PIC16(L)F1934/1936/1937 Family Silicon Errata and Data Sheet Clarification

The PIC16(L)F1934/1936/1937 family devices that you have received conform functionally to the current Device Data Sheet (DS41364E), except for the anomalies described in this document.

FIGURE 1: INSTRUCTION CYCLE DELAY CALCULATION EXAMPLE

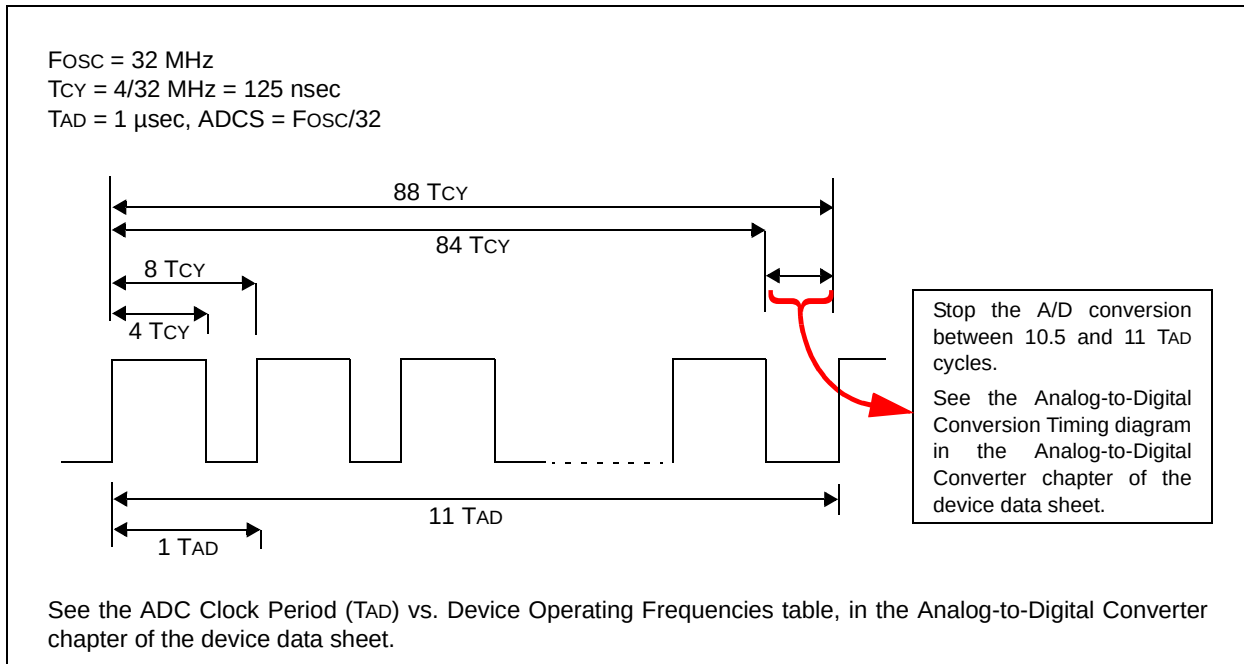
An ADC conversion may not complete under these conditions:

1. When F_{osc} is greater than 8 MHz and it is the clock source used for the ADC converter.
2. The ADC is operating from its dedicated internal FRC oscillator and the device is not in Sleep mode (any F_{osc} frequency).

When this occurs, the ADC Interrupt Flag (ADIF) does not get set, the GO/DONE bit does not get cleared, and the conversion result does not get loaded into the ADRESH and ADRESL result registers.

Method 3: This method is provided if the application cannot use Sleep mode and requires continuous operation at frequencies above 8 MHz. This method requires early termination of an ADC conversion. Provide a fixed time delay in software to stop the A-to-D conversion manually, after all 10 bits are converted, but before the conversion would complete automatically. The conversion is stopped by clearing the GO/DONE bit in software. The GO/DONE bit must be cleared during the last $\frac{1}{2}$ TAD cycle, before the conversion would have completed automatically. Refer to [Figure 1](#) for details.

In [Figure 1](#), 88 instruction cycles (Tcy) will be required to complete the full conversion. Each TAD cycle consists of 8 Tcy periods. A fixed delay is

provided to stop the A/D conversion after 86 instruction cycles and terminate the conversion at the correct time as shown in the figure above.

Note: The exact delay time will depend on the TAD divisor (ADCS) selection. The Tcy counts shown in the timing diagram above apply to this example only. Refer to [Table 3](#) for the required delay counts for other configurations.
